Sundry Print Report

Well Name: SEAWOLF 12-1 FED

Type of Action: APD Change

Procedure Description: Devon Energy Production Company, L.P. respectfully requests approval for optional surface casing/drilling plan of 10-3/4" surface casing inside of 12-1/4" surface hole at previously permitted set depths. Devon Energy Production Company, L.P. will circulate class C cement to surface behind the 10-3/4'' casing. Devon Energy is also requesting a break test variance. Please see the attached documentation.

Cactus Wellhead

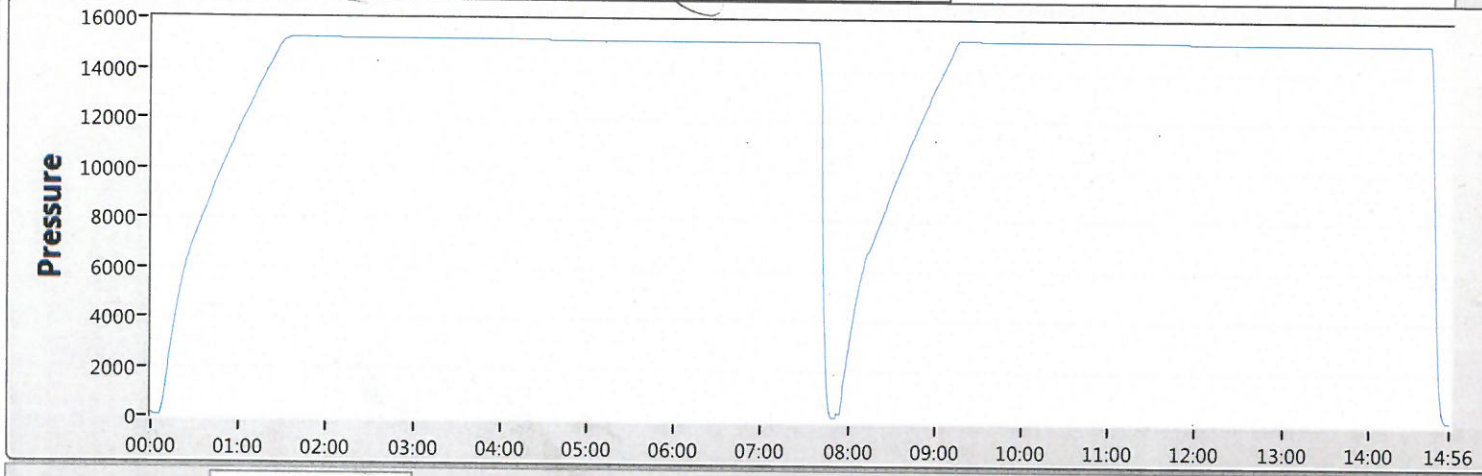
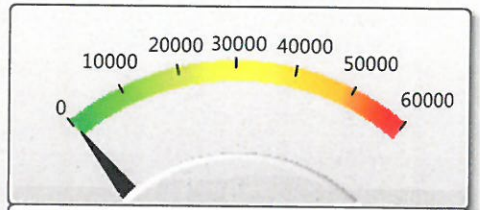
Devon Energy requests to only test BOP connection breaks after drilling out of surface casing and while skidding between wells which conforms to API Standard 53 and industry standards. This test will include the Top Pipe Rams, HCR, Kill Line Check Valve, QDC (quick disconnect to wellhead) and Shell of the 10M BOPE to 5M for 10 minutes. If a break to the flex hose that runs to the choke manifold is required due to repositioning from a skid, the HCR will remain open during the shell test to include that additional break. The variance only pertains to intermediate hole-sections and no deeper than the Bone Springs Formation where 5M BOP tests are required. The initial BOP test will follow OOGO2.III.A.2.i, and subsequent tests following a skid will only test connections that are broken. The annular preventer will be tested to 100% working pressure. This variance will meet or exceed OOGO2.III.A.2.i per the following: Devon Energy will perform a full BOP test per OOGO2.III.A.2.i before drilling out of the intermediate casing string(s) and starting the production hole, before starting any hole section that requires a 10M test, before the expiration of the allotted 14-days for 5M intermediate batch drilling or when the drilling rig is fully mobilized to a new well pad, whichever is sooner. We will utilize a 200' TVD tolerance between intermediate shoes as the cutoff for a full BOP test. The BLM will be contacted 4hrs prior to a BOPE test. The BLM will be notified if and when a well control event is encountered. Break test will be a 14 day interval and not a 30 day full BOPE test interval. If in the event break testing is not utilized, then a full BOPE test would be conducted.
